**GENAN, INC.'S RESPONSE TO CITIZENS
FOR RESPONSIBLE RECYCLING'S MOTION
TO OVERTURN REGARDING ISSUANCE OF SCRAP TIRE
STORAGE FACILITY REGISTRATION NO. 6200673 TO GENAN, INC.**

Re: Amended Application by Genan, Inc. for a scrap tire storage facility
registration

Re: Revised Scrap Tire Storage and Processing Facility (and Transporter) Registration Application dated July 16, 2010 (the "Application") filed by Genan Inc. ("Genan") with the Texas Commission on Environmental Quality ("TCEQ") pertaining to property located at 18038 Beaumont Highway, Houston, Harris County, Texas (the "Property").

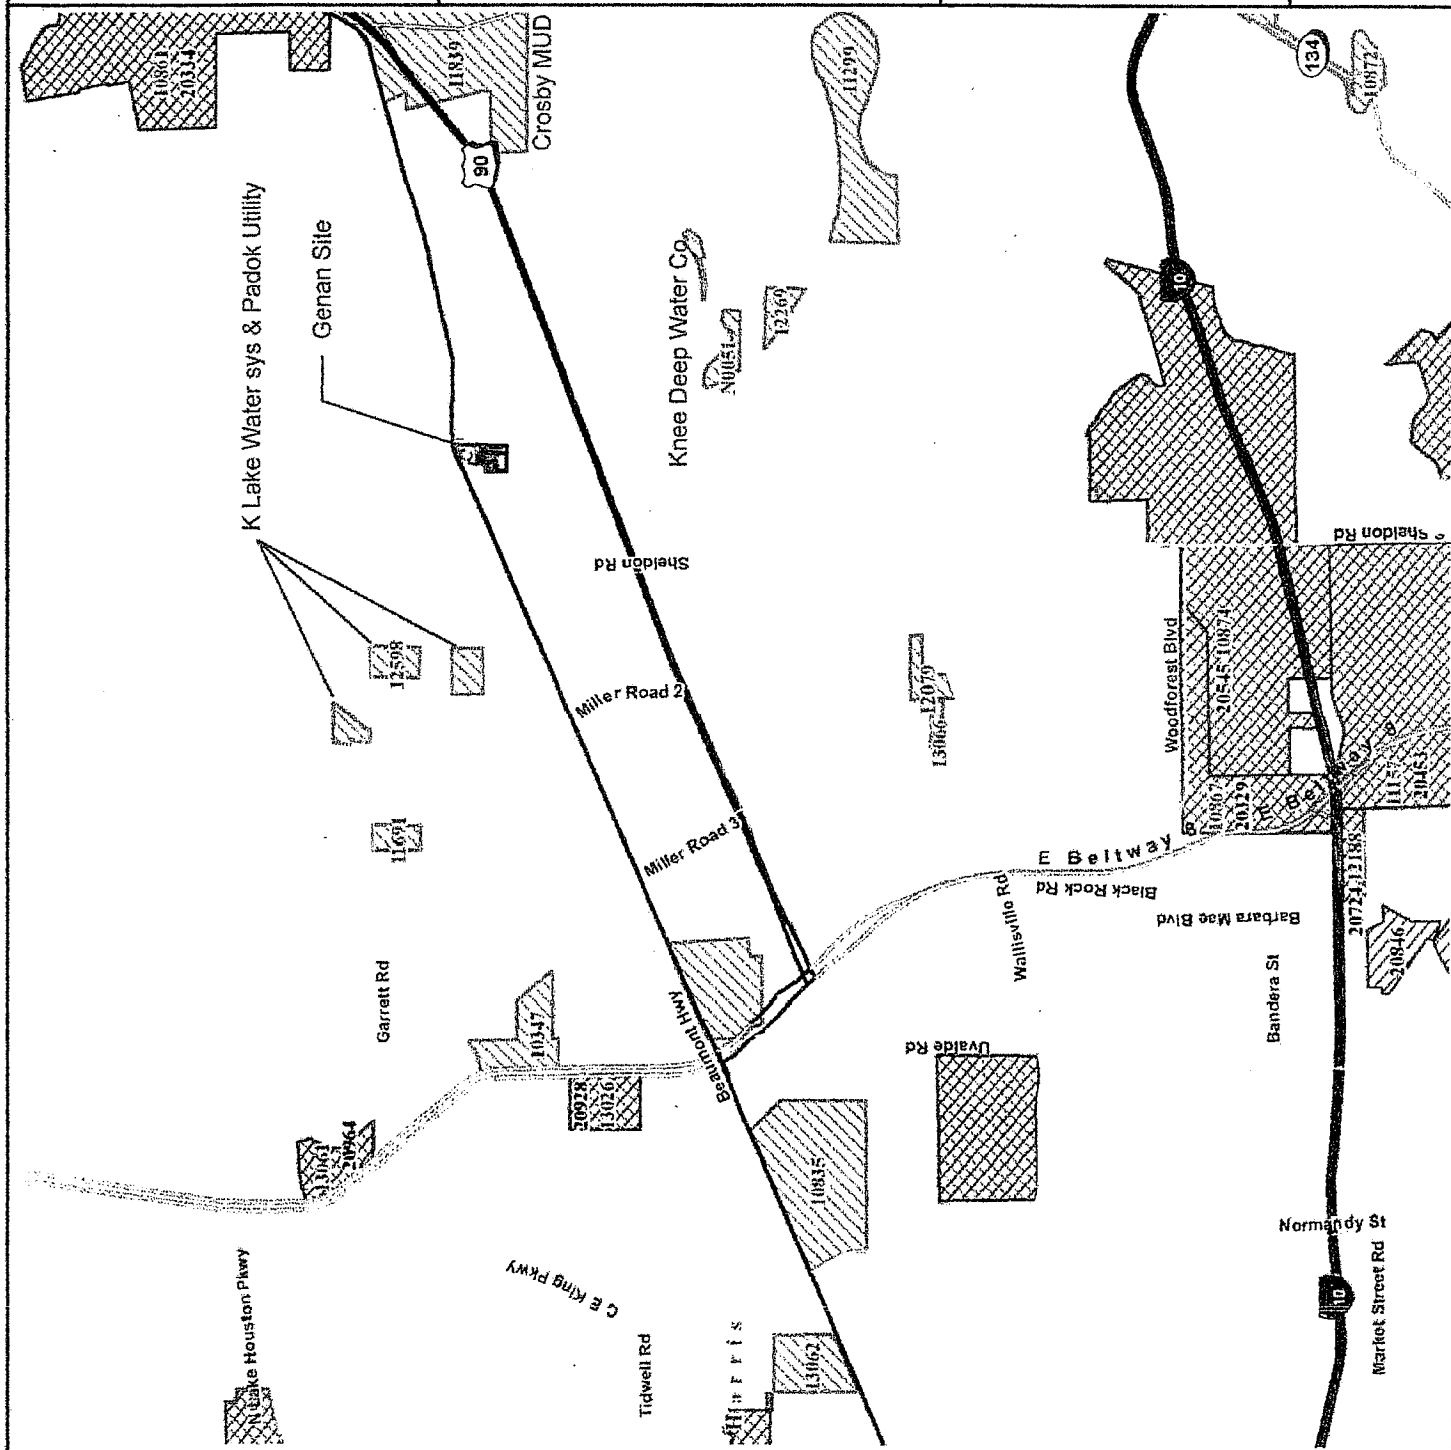
4. Claim: It also appears that at least some of the property within 500 feet of the proposed facility is part of a municipal utility district ("MUD"). Yet, there is no indication that the MUD has been notified of the proposed facility. This MUD should be notified; it is possible that the MUD holds easements within 500 feet of the proposed facility.

Response: Genan gave proper notice and delivered copies of the Original Application and the revised Application to all required entities. We have attached to this letter a map from the TCEQ which shows all MUD and CCN's in the area. The closest MUD is 2.1 miles to the east of the Property, and the closest CCN is 1.4 miles to the northwest of the Property. The Harris County Appraisal District map shows a NE HC MUD 1; however, the TCEQ's records do not show a MUD with that name, as the attached list of water districts shows.
